City of Richmond
Planning and Development Department

**Report to
Development Permit Panel**

File: DP 07-358875

Re: **Application by Jacken Investments Inc. for a Development Permit at 11351, 11391, 11411, 11431, 11471 and 11491 Steveston Hwy.**

PLAN #3.

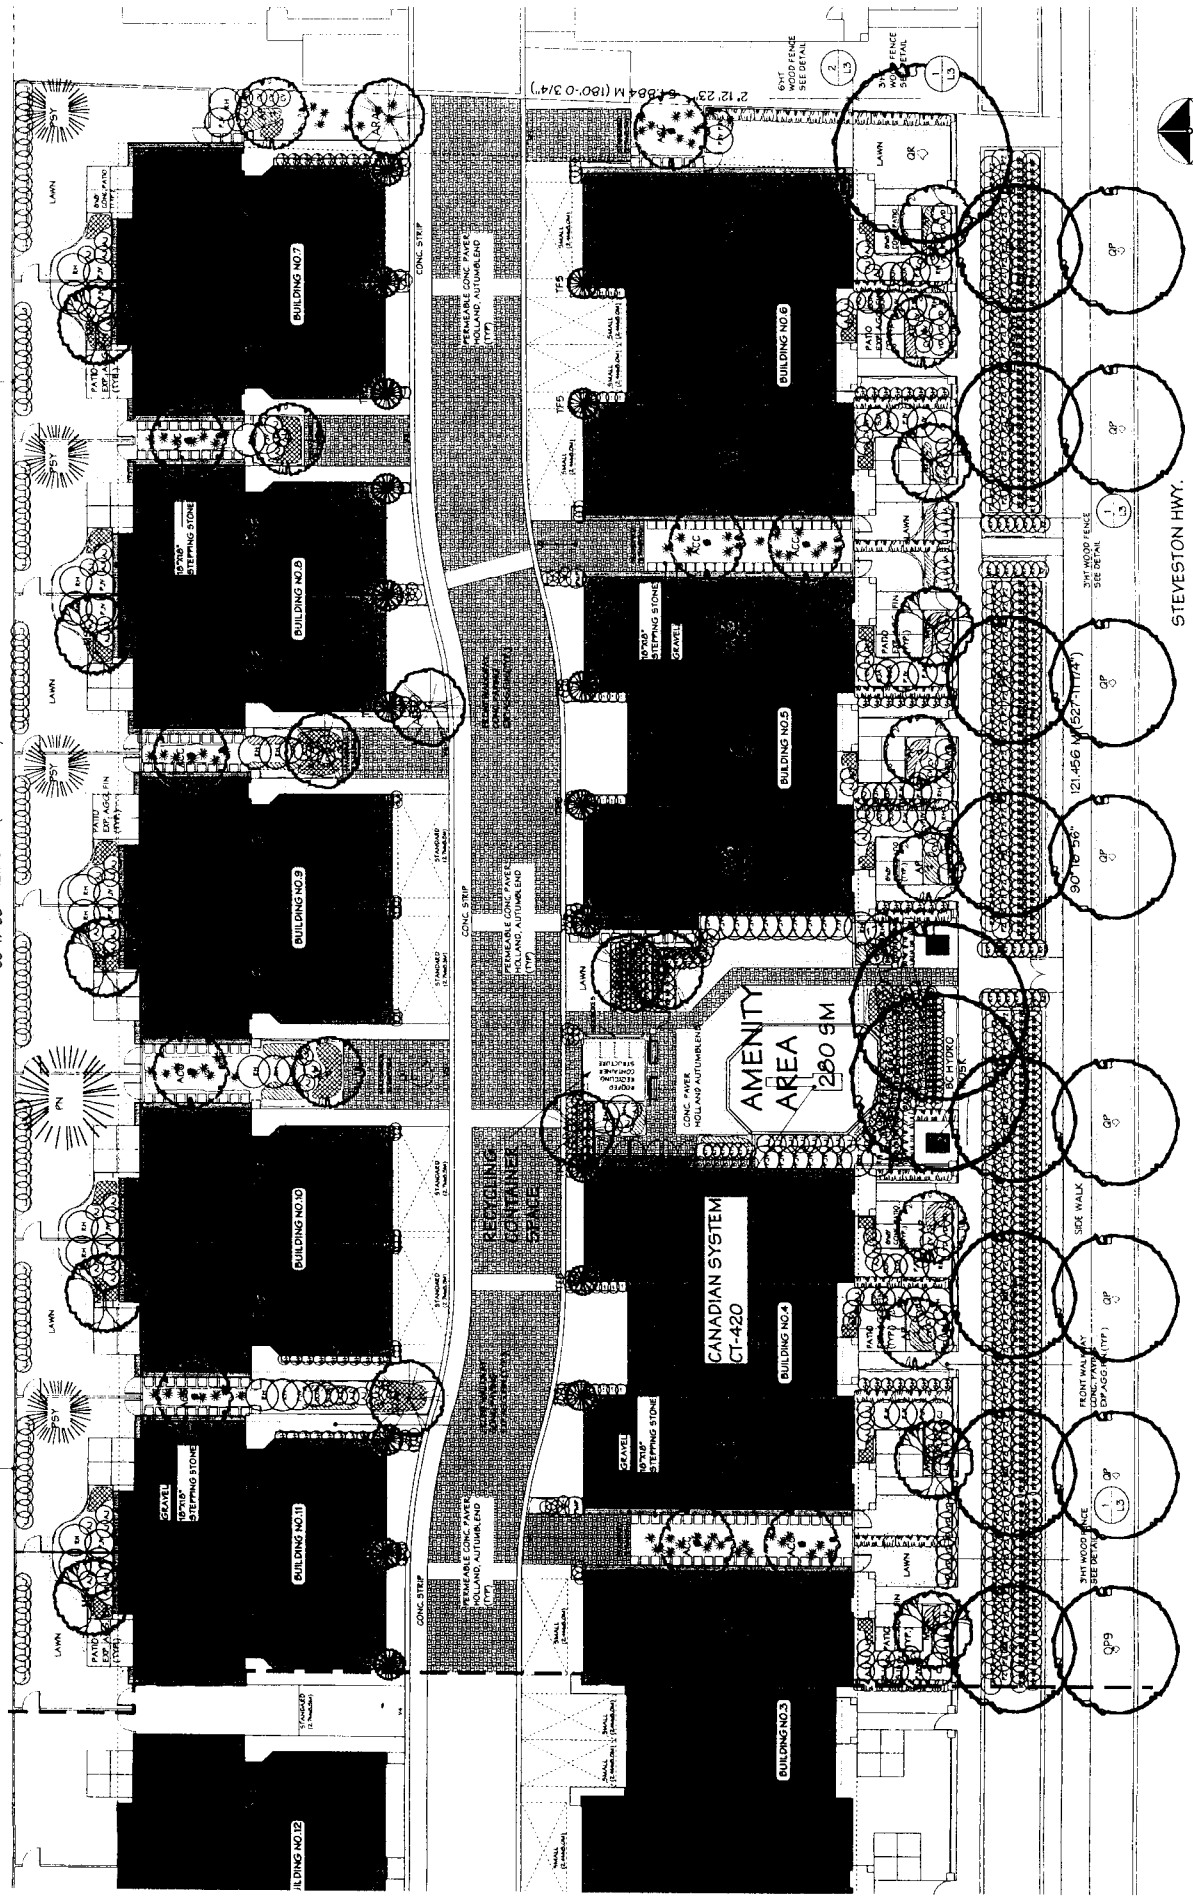
2. *explore opportunities to plant coniferous trees on site;*

Response: Refer to Landscape drawings.

1 ARBOUR BY AMENITY AREA

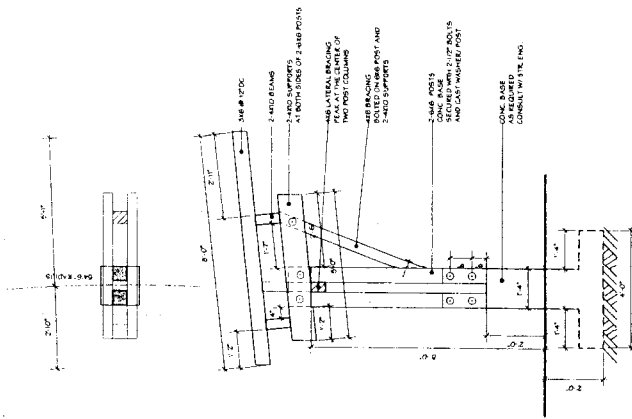
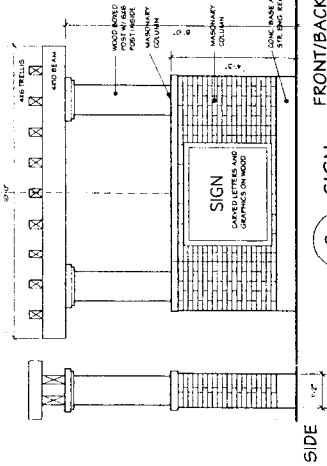
5. *additional architectural emphasis to the entrance.*

Response: Refer to Landscape drawings for trellis features at entry.

DP 07-358875
PLAN #4

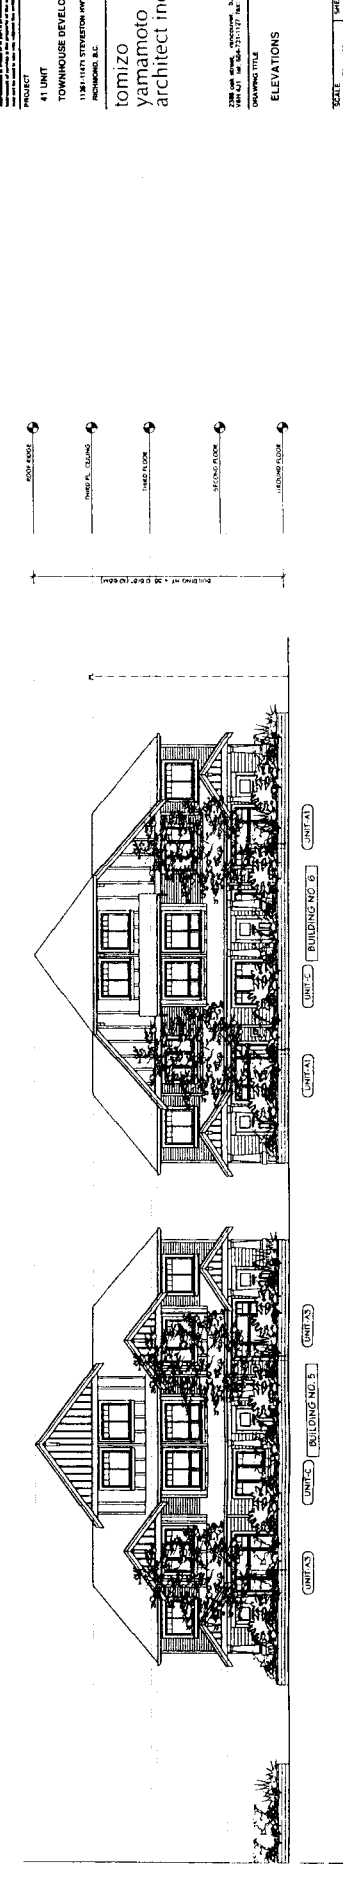
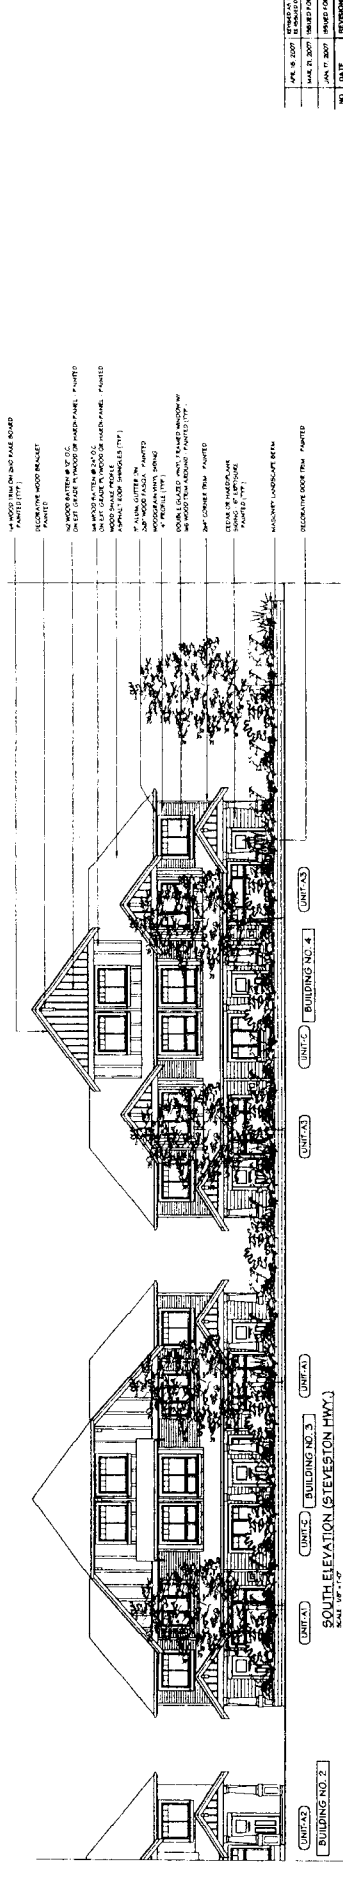
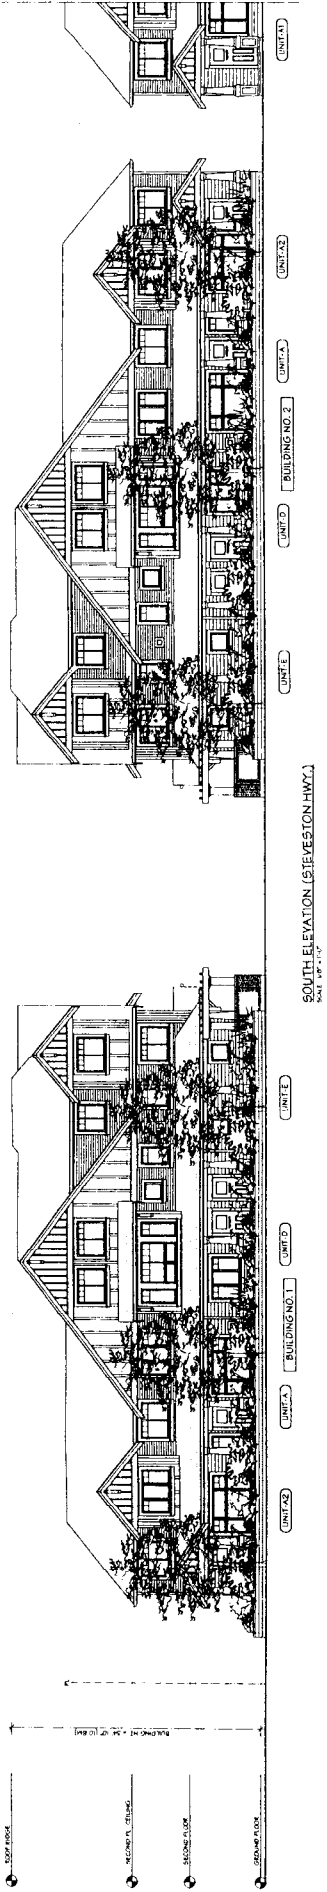
4. *additional architectural emphasis to the roof line expressions on the north side;*

Response: Roofs alternated between hip and gable forms along internal driveway.
